Re: Public Version of the Selected Assumptions Summary Report for the Indiana 2016 IRPs

Confidential Selected Assumptions Summary Report for Indiana 2016 IRPs (Public Version)

Figure 1. AEG 2016 NIPSCO and IPL MPS Residential measure achievable adoption rates

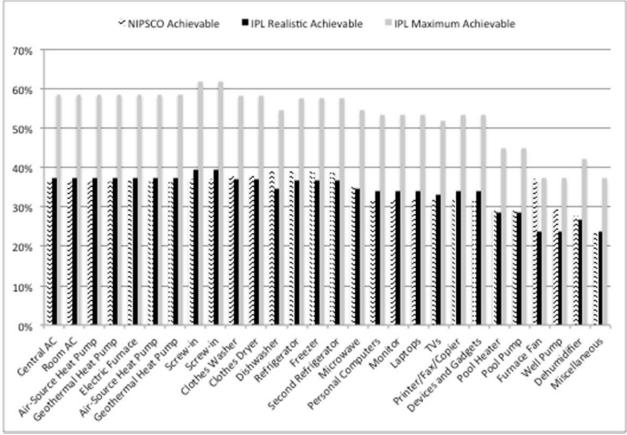
Figure 1 raises several critical questions regarding AEG's method for estimating achievable potential:

- 1. The NIPSCO "Achievable" adoption rates are very similar to the IPL Realistic Achievable rates. Can NIPSCO's "Achievable" potential, therefore, be viewed as a <u>lower boundary</u> on achievable potential? If it can, this means that any calculation of the Maximum Achievable potential is absent from NIPSCO's study.
- 2. The AEG Project Director was the same person for both the NIPSCO and IPL 2016 MPSs; several other AEG staff members also worked on both reports. Why then do these reports use different definitions of Achievable Potential?
- 3. If there are data to back up this range of adoption rates as appropriate, then it would appear that different circumstances result in different adoption rates for the same measures. Can the circumstances associated with these divergent adoption rates speak to how efficiency programs are best designed so as to maximize participation and

savings? Put another way, should Figure 1 be interpreted to reveal that NIPSCO is assuming that it will design its programs in a suboptimal manner?
